Access Compliance Report

Public Rights-of-Way

(Curb Ramps)

Intersection ID: N/A	Main Street: SUMMERFIELD RIDGE LN	Cross Street: MILL VALLEY CT	Location: W
ADA ID: BAFA58B6AA60	Ramp Type: PerpDiag	Initial Pass/Fail: Pass	Overall Compliance: No
Severity Score: 7.5			
Codes/Mitigation Info/Possible Solution		Field Measurements/Component Compliance

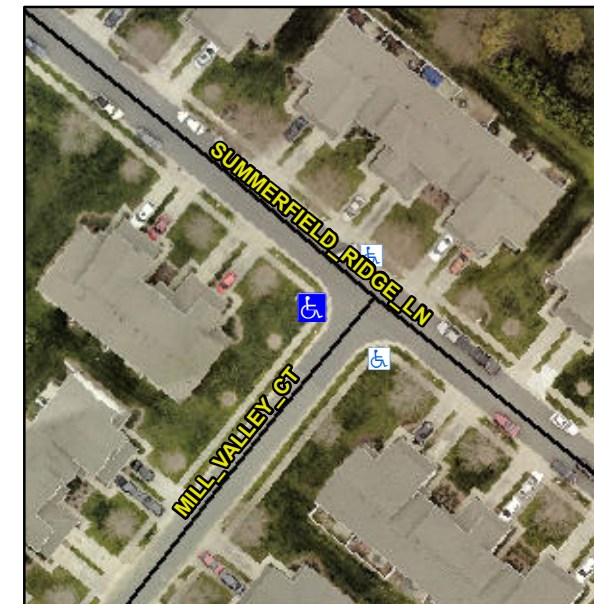
Remove & Replace Curb Ramp With Two New Directional Ramps or Equivalent. Remove & Replace Gutter.

R304.2.1, R304.2.2-Perp, R304.3.2-Para, R305.1.4, R305.2, R304.5.4
